# UNITED STATES PATENT AND TRADEMARK OFFICE

10/507,975

## Office Action Summary

Ramesh Krishnamurthy

Fig. 2

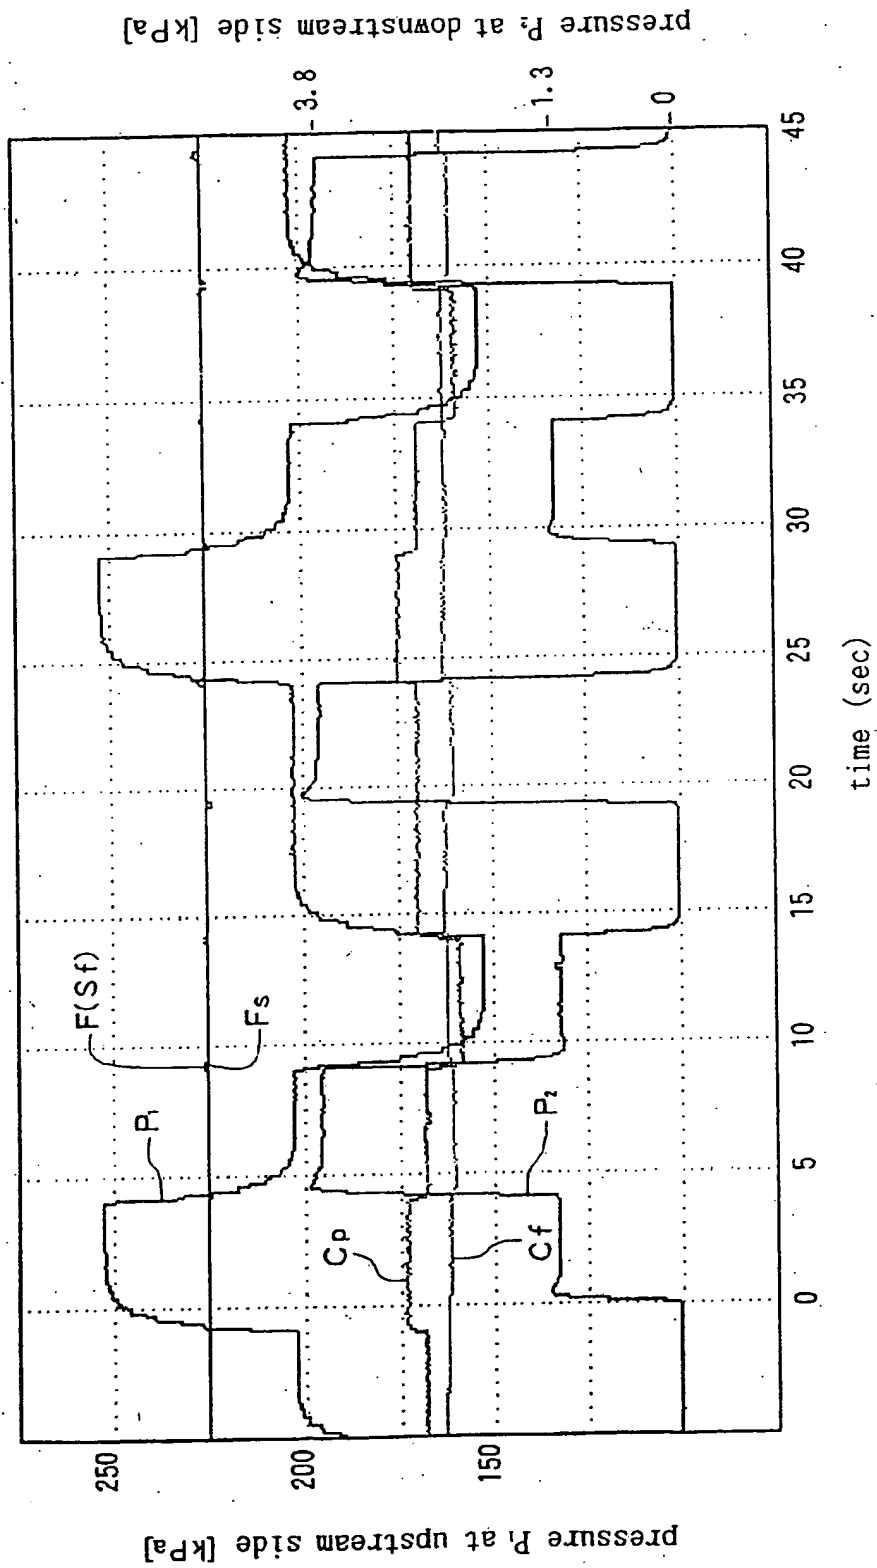
Approved  
RK  
02/18/07

Fig. 3

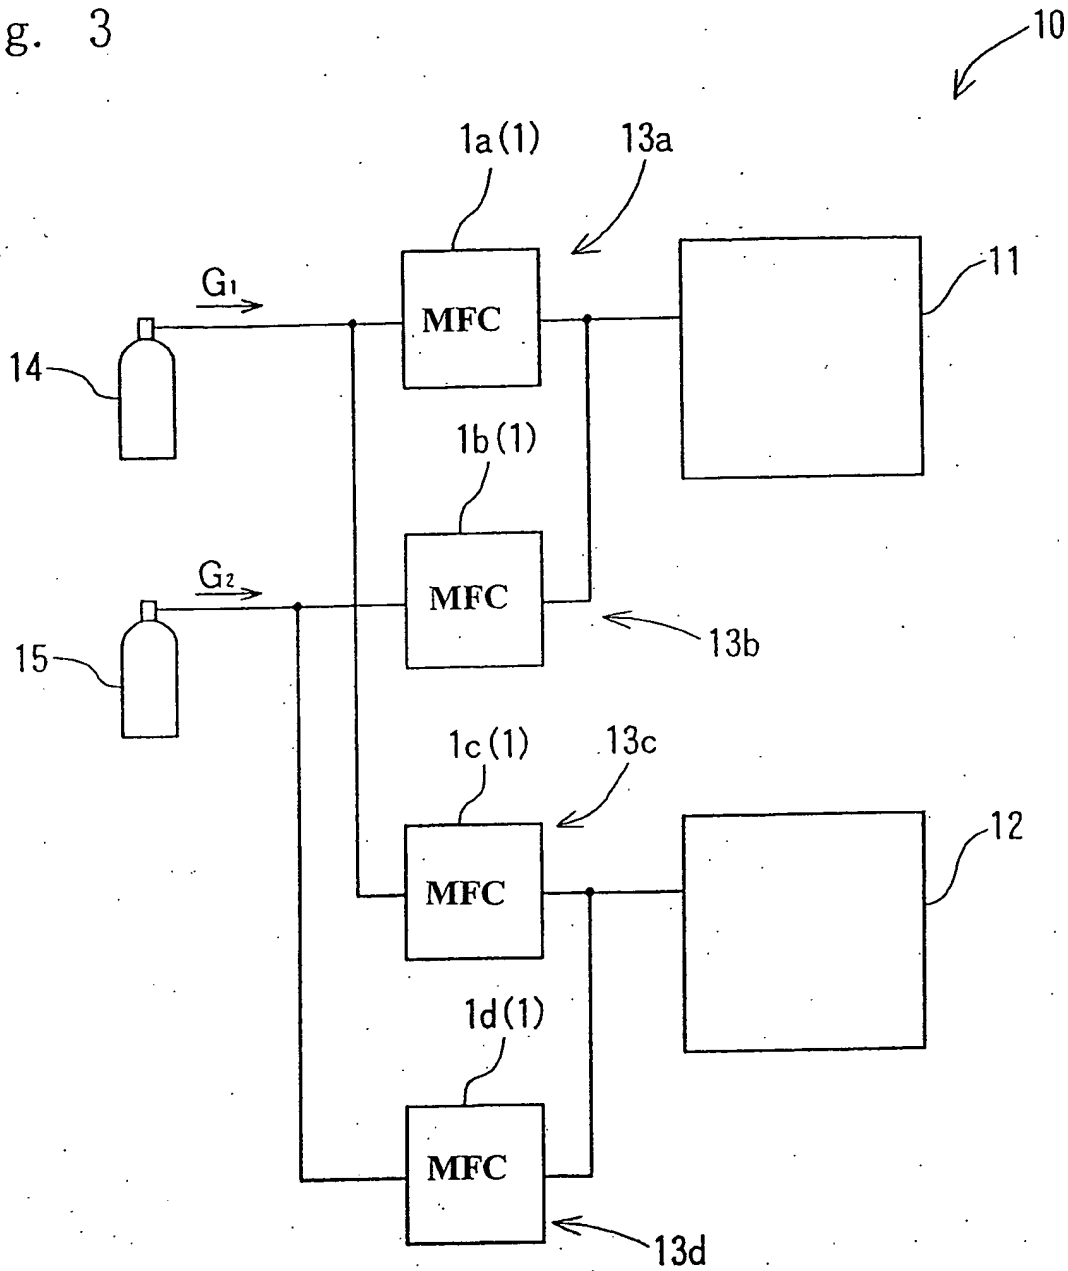
Approved  
RK  
02/18/07

Fig. 4

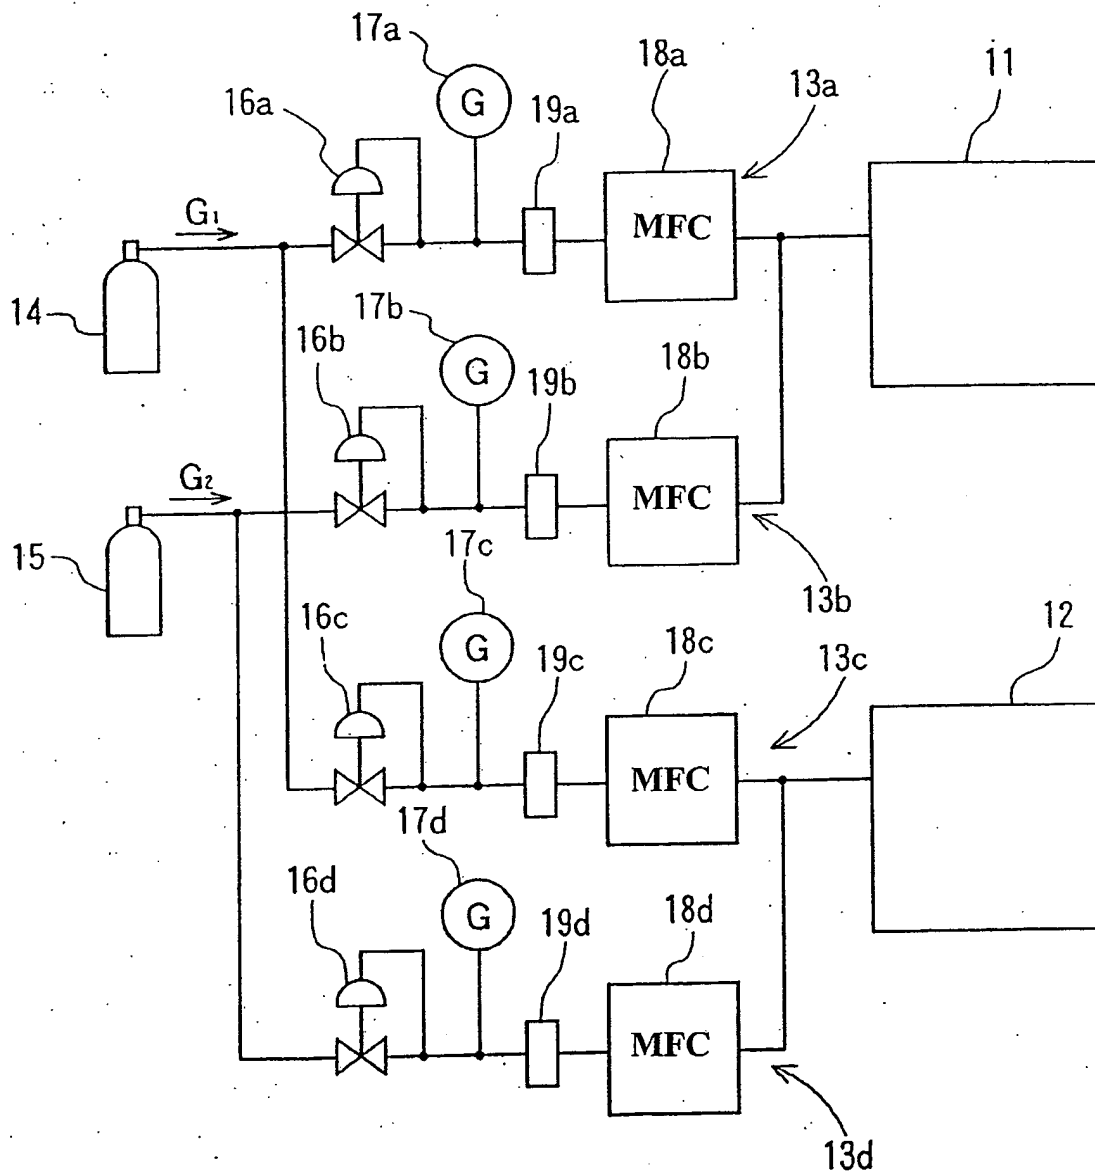
Approved  
RK  
02/18/07

Fig. 5

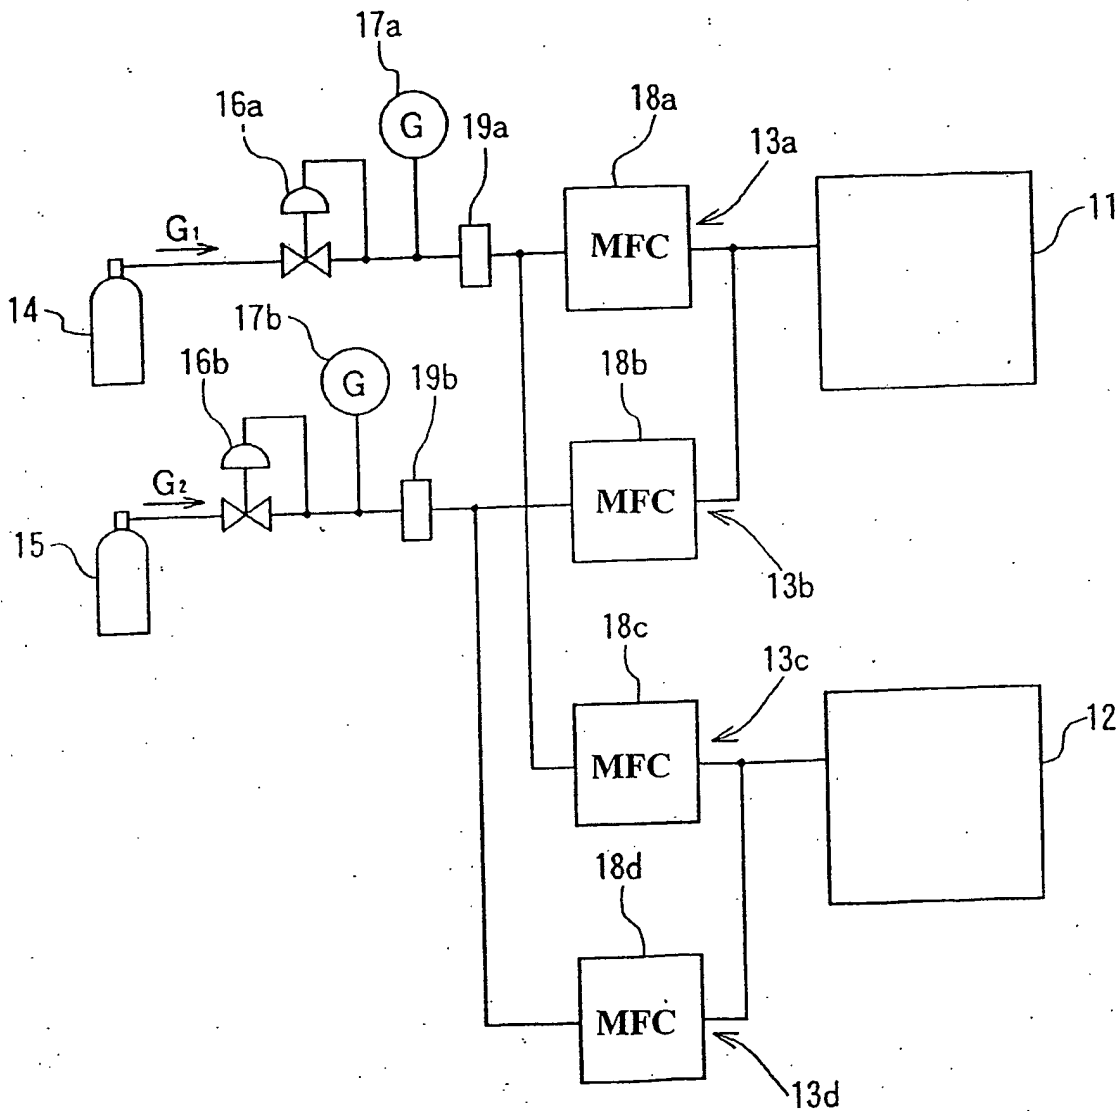
Approved  
RK  
02/18/07
